ADDENDUM #1

September 18, 2026

2027 Roof Replacement at Wyandot Elementary School
Dublin City School District Board of Education
5620 Dublinshire Drive
Dublin, Ohio 43017

Mays Project #: DOH43-011-03

4 OPEN VALLEY DETAIL

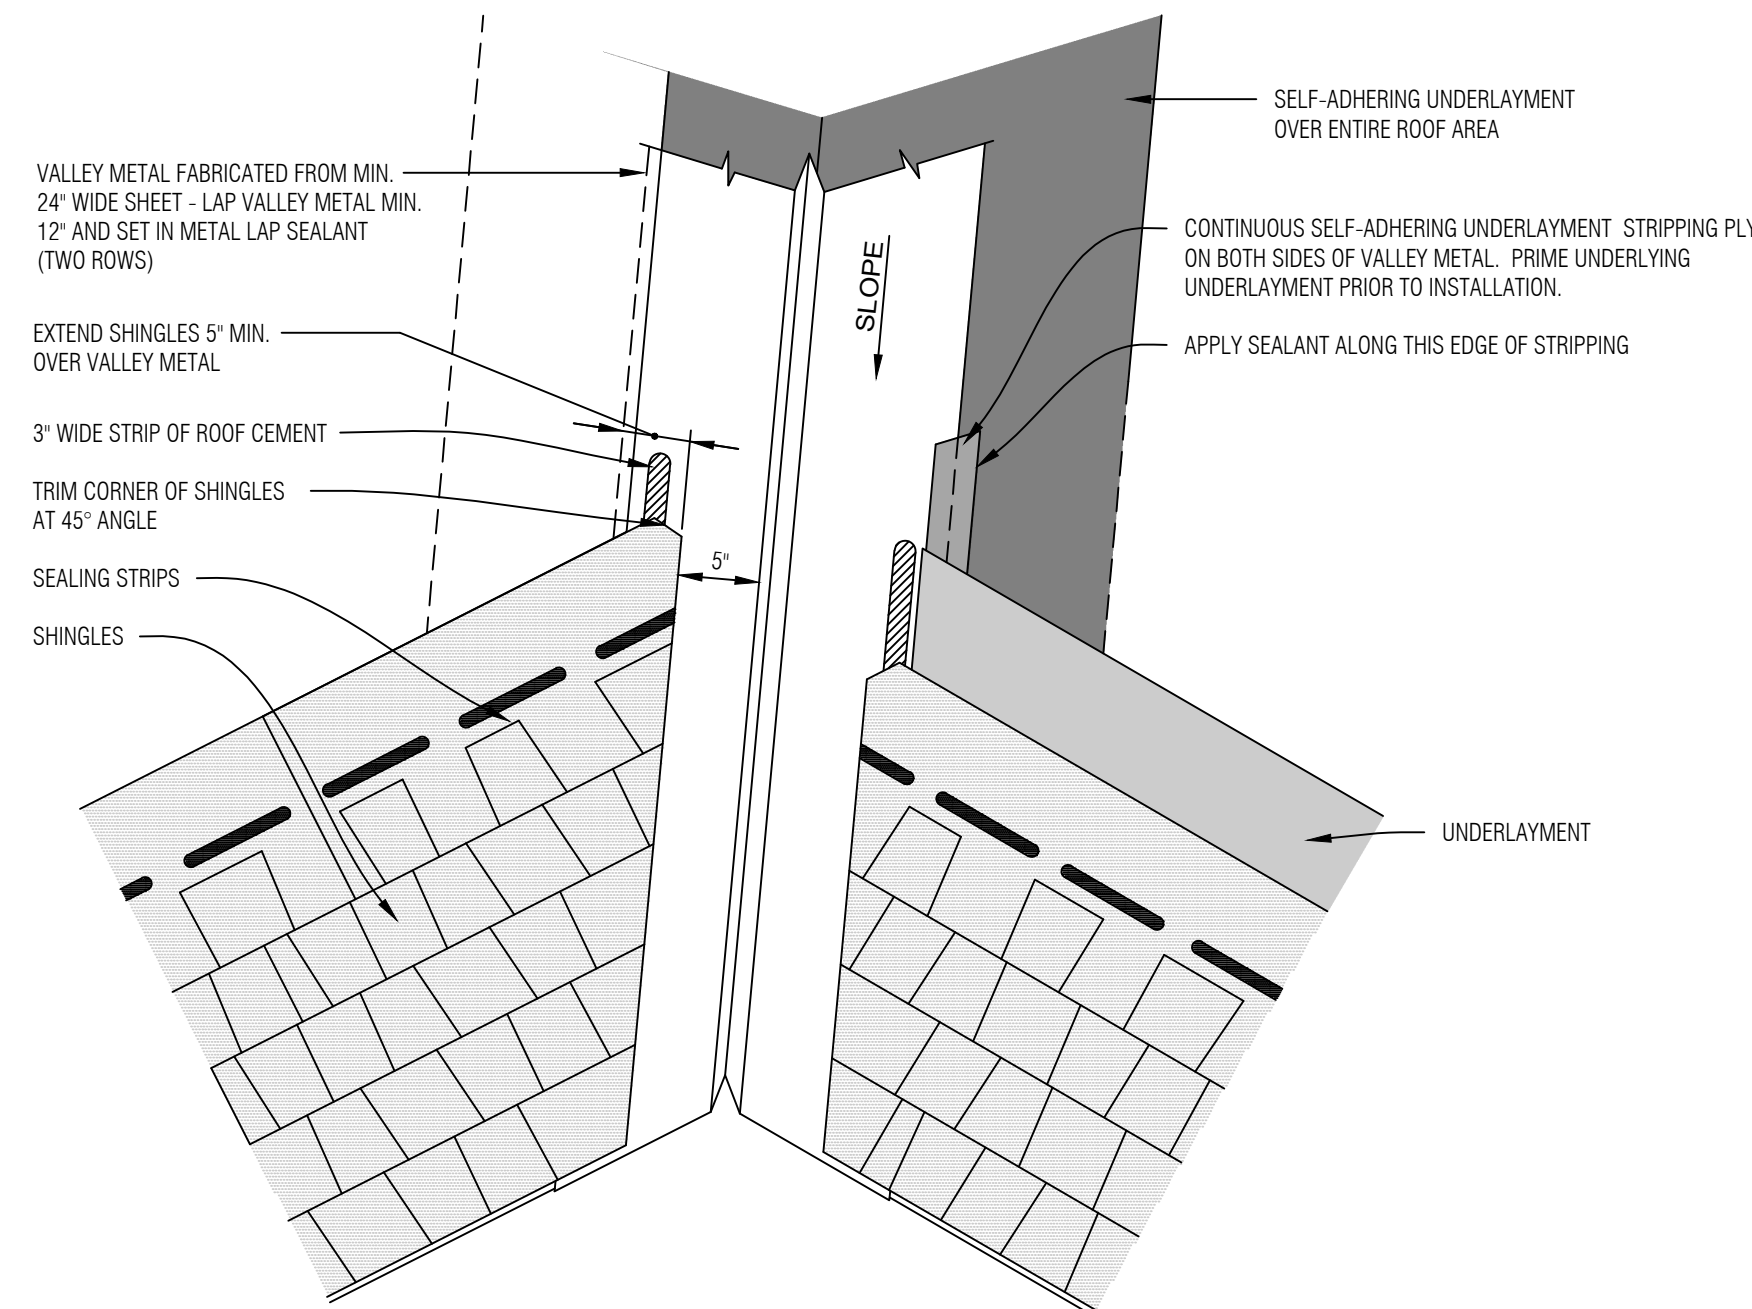
Drawing No(s):	Detail 4/A5.2		
Request:	Detail 4/A5.2 indicates 2" wide cleat at 18" o.c., while the project specification section 07 62 00 requires valley-edge cleats at 24" o.c. Please clarify the required valley cleat spacing.		
Recommendations:			
Impact:	N/A		
Attachment(s):	N/A		
Requested by:	Duncan McClung, Almost Heaven Roofing	Date of Request:	September 17, 2026
Title:	Estimator	Date Reply Required:	
The cleats for the valley shall be installed a maximum of 24" o.c. Detail 4/A5.2 will be revised in Addendum #1 to reflect this requirement.

3 BUILT-IN COLLECTOR BOX DETAIL
A5.4 SCALE: NONE

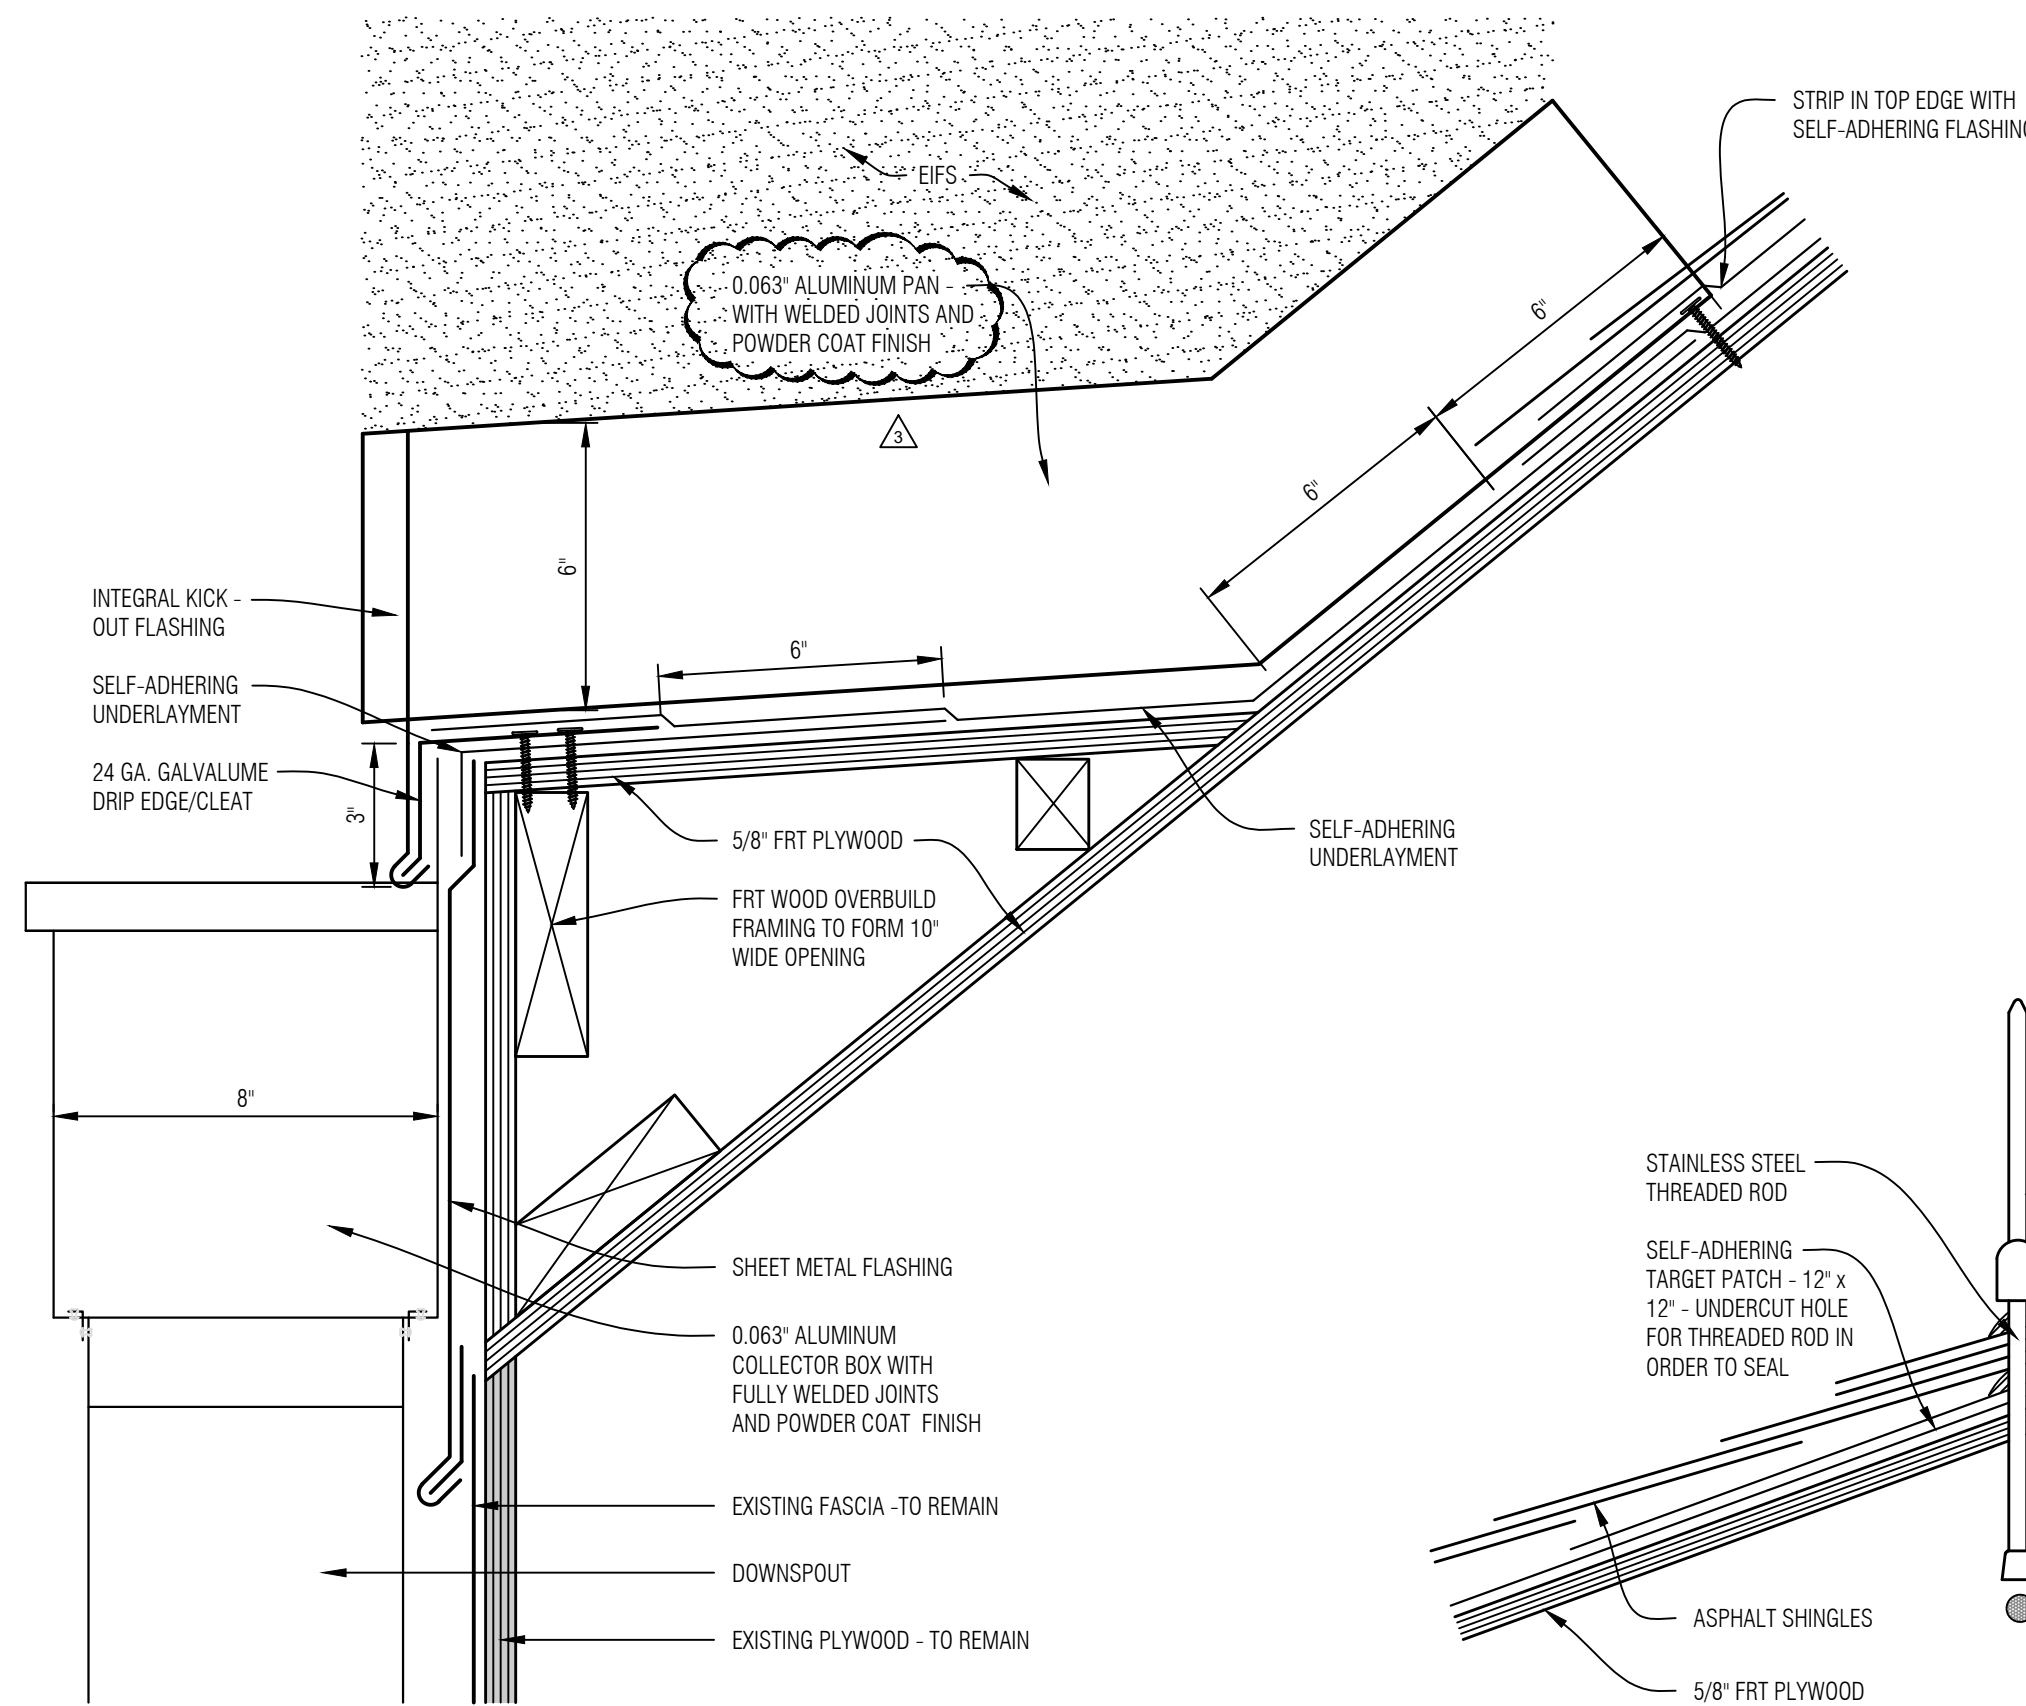
1. The composition and finish of the pan flashing (Detail 3/A5.4) at the collector box has been clarified.
2. The drawings have been revised to clarify that the soffit (i.e. intake) vents are to be enlarged as part of the Base Bid work. In addition, the drawings were clarified that the same ventilation requirements also apply to the Alternate #1 work.
3. The spacing of the cleats for valley cleats was clarified to be 24" o.c.
4. Replacement of and deteriorated steel decking was clarified that it will be completed on a unit price basis and there is no allowance for this work.
5. Alternate #3 was added to replace the existing coping cap and extender on Roof Area A in order to change the color of this coping cap to match the color of the recently installed coping cap on the remainder of the school.

NOTES:
1. PAN FLASHING TO HAVE A POWDER COAT TO COMPLY WITH AAMA 2605, COLOR TO MATCH FASCIA.
2. COLLECTOR BOX DIMENSIONS TO BE DETERMINED BASED ON FIELD MEASUREMENTS. CONTRACTOR TO SUBMIT PROPOSED DIMENSIONS DURING SUBMITTAL PHASE, FOR REVIEW AND APPROVAL.
